Access Compliance Report

Public Rights-of-Way

(Curb Ramps)

Intersection ID: 11980	Main Street: ALLEN_ST	Cross Street: E_17TH_ST	Location: W
ADA ID: 1EC788B62521	Ramp Type: Directional1	Initial Pass/Fail: Pass	Overall Compliance: No
Codes/Mitigation Info/Possible Solution		Field Measurements/Component Compliance	
Severity Score: 10

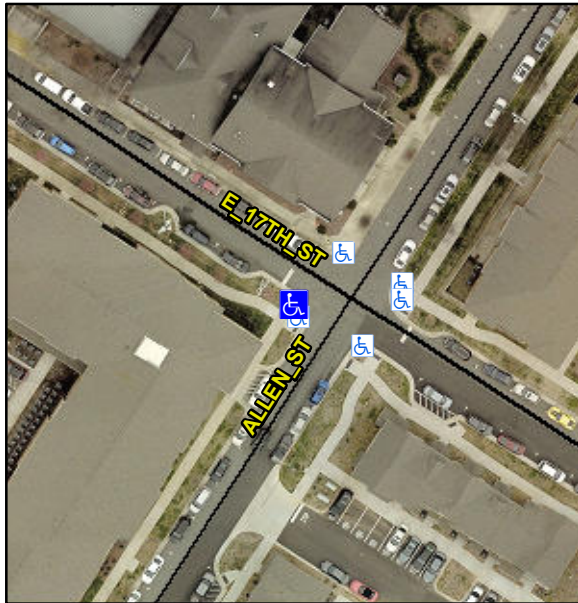
R305.1.4, R305.2, R302.7.2

Compliance	Description	Data	Compliance	Description	Data
N/A	Ramp Length (in)	102.0	Yes	Grade Break?	Yes
Yes	Ramp Width (in)	56.0	Yes	Grade Break Slope (%)	4.1
Yes	Ramp Slope (%)	4.7	Yes	Grade Break XSlope (%)	1.7
Yes	Ramp XSlope (%)	0.6			
Yes	Flare Type LT	N/A	Yes	Flare Type RT	N/A
N/A	Flare Slope LT (%)	N/A	N/A	Flare Slope RT (%)	N/A
N/A	Flare Traversable LT?	No	N/A	Flare Traversable RT?	No
Yes	Landing Length (in)	72.0	Yes	DWS Provided?	Yes
Yes	Landing Width (in)	71.0	Yes	DWS Contrast?	Yes
Yes	Landing Slope (%)	0.9	Yes	DWS Length (in)	24.0
Yes	Landing X Slope (%)	1.4	No	DWS Full Width?	No
N/A	Landing Curb? (Y/N)	No	No	DWS Offset LT (in)	4.5
N/A	Shared Landing?	No	Yes	DWS Offset RT (in)	11.0
Yes	Gutter Ponding?	No	Yes	Gutter Slope (%)	3.8
No	Gutter Lip Ht (in)	0.3	Yes	Gutter X Slope (%)	0.4
N/A	Painted X Walk1?	No		Road Slope (%)	0.7
	X Walk 1 Direction	To NE		Road X Slope (%)	2.2
	X Walk 1 Width (in)	N/A		Clear Space?	Yes

X Walk 1 Slope (%)	0.7	N/A	Clear Space to XWalk (in)	N/A
	X Walk 1 X Slope (%)	2.2	Yes	Storm Grate/Utility Hazard?	No
N/A	Ramp inside XWalk1?	N/A		Storm Grate/Utility Type	
Yes	Any Obstructions?	No			N/A
	Obstruction Type		Yes	Surface Condition? (G/P)	Good
			N/A	Curb Slope (%)	4.7

Remove & Replace Detectable Warning System. Grind Gutter Lip.
